#### HISTORIC AND DESIGN REVIEW COMMISSION

**HDRC CASE NO:** 2015-413

**ADDRESS:** 312 PEARL PKWY

**TYPE OF WORK:** Signage

## **Pearl - Lick Honest Ice Creams** Window Vinyl

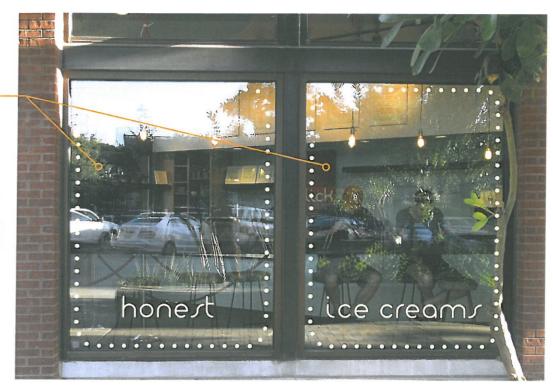
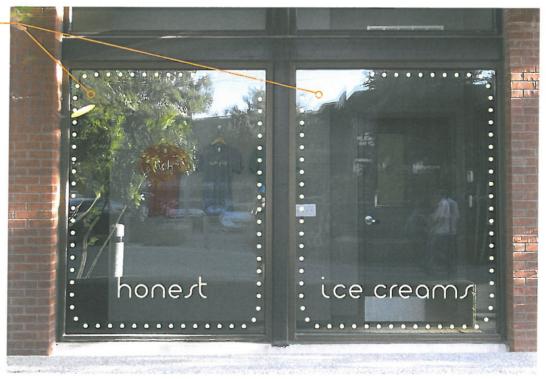
- b. The applicant has proposed to install perimeter storefront window vinyl on eight windows with the following sizes 5'-4" in width by 7' in height on two windows, 5'-4" in width by 7'-2" in height on five windows and 2'-3" in width by 7'-2" in height on one window. The applicant has proposed colors of cream (PMS 607 U) and red (PMS 1797 C). This signage is to read "honest" and "ice creams". Overall, the total requested square footage for the proposed window vinyl is approximately 280 square feet. Staff does not find this amount of signage appropriate. Staff recommends the applicant reduce the amount of overall window signage to a size appropriate for its setting and objective.

# Pearl - Lick Honest Ice Creams Lick Canopy Signage

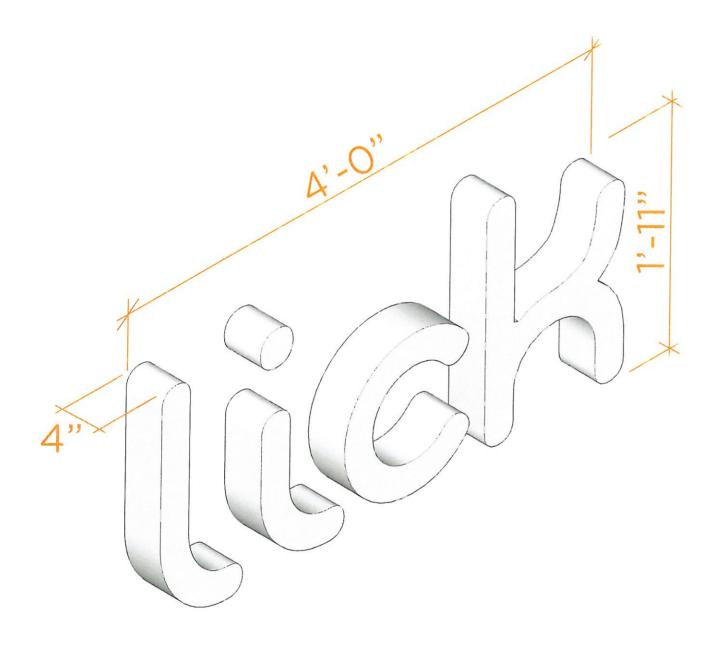
- c. Above the existing canopy, the applicant has proposed to mount an aluminum sign of dimensional letters that together are to be 4'-0" in length, 1'-11" in height and 4" in depth. The applicant has proposed to match the cream color of the proposed window signage. The applicant has not proposed to light this signage at this time. Staff finds this request appropriate and consistent with the UDC.

## Pearl - Lick Honest Ice Creams Canopy Pendant Sign

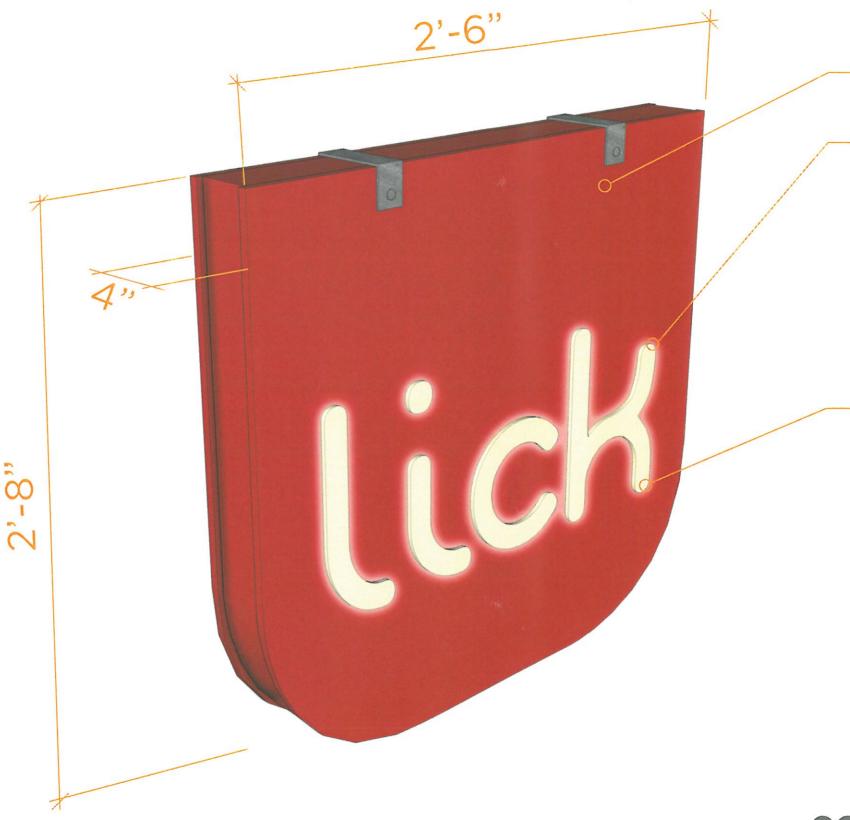
- d. Beneath the existing canopy, the applicant has proposed to install two, double faced, signs with acrylic push through letters reading "lick" that are to measure 2'-8" in height, 2'-6" in width and 4" in depth. These proposed signs will be internally lit, gloss painted pendant cabinets with acrylic push through letters. Approximate square footage for both signs is twenty-five (25) total square feet. Staff finds this request appropriate and consistent with the UDC.
